**SUZUKI**

Service Bulletin

Bulletin No: GT-34
Date: Mar. 26, 1976

Service APPSubject: GT500 SHIFTING CAM GUIDE BOLT LOCATION
REFERENCE: Service Bulletin #T-5NOTICE:

Bottom View of Lower Crankcase Hal

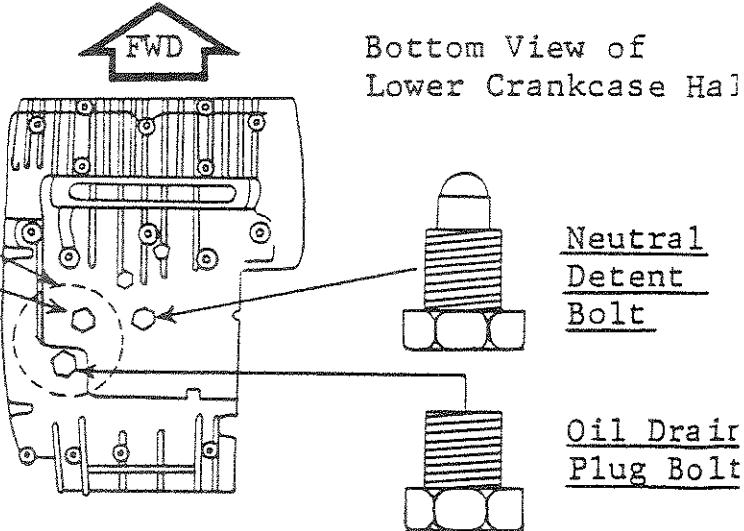
We have received occasional reports of GT500 transmission failure immediately after an engine or transmission overhaul. Upon disassembling and inspecting the transmission, it was found that the transmission oil drain plug and the shift cam guide bolt had been mistakenly interchanged during the overhaul.

NOTE: Remove both bolts to drain oil. After draining oil make sure of correct placement of both bolts.

The shift cam guide bolt restricts the shift cam drum from sliding from side to side inside the crankcase assembly. When these two bolts are interchanged, the oil drain plug does not extend into the locating groove of the shift cam drum, allowing the drum to slide from side to side. When this happens the shifting forks slide with the shift cam, allowing two sets of gears to become engaged at the same time. This results in severe damage to the gears, and requires their replacement.

Therefore, whenever a GT500 is overhauled, or the transmission oil changed by your service department the final inspection after reassembly should be the proper placement of the shift cam guide bolt and oil drain plug.
